# AUI-C2M host and module input specifications

(comments #188, #189 against D1.0)

Adee Ran, Cisco

# Proposed test setups for C2M

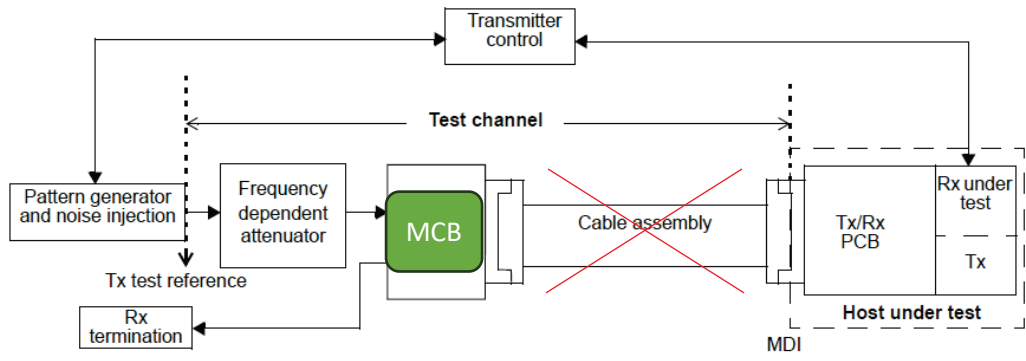
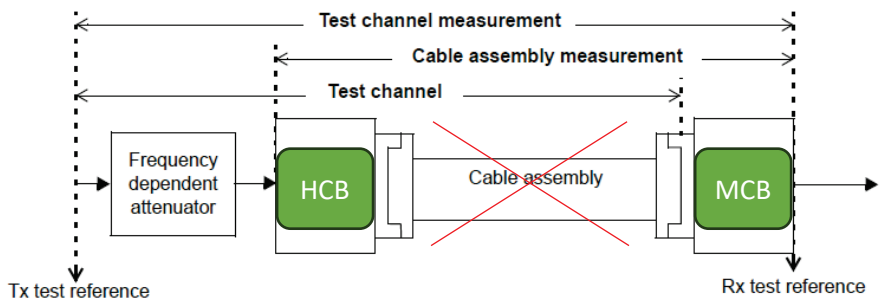
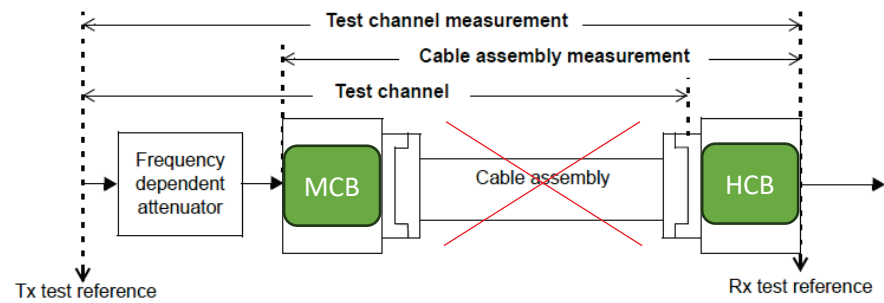
- Test channel insertion loss:
  - For **host input**: one test, minimal loss (no cable, no remote host) defined by the mated HCB+MCB (MTF)
  - For **module input**:
    - Test 1 – MTF with additional frequency dependent attenuator (FDA) to get the maximum loss host channel (proposed 35 dB)
    - Test 2 – similarly but with FDA loss of (proposed 6 dB) plus the MTF, representing the minimum loss case (a small host package with board similar to the MCB)
- Test channel calibration (additive noise to achieve target COM):
  - For **module input**: same as the test channel
  - For **host input**: include FDA representing the DUT's channel, such that with addition of the MTF, you get (35 dB) – identical to module input test 1 above.
- Error requirements:
  - Point to annex 174A
  - Should be defined in same terms as CR but with different values (not covered by this presentation)
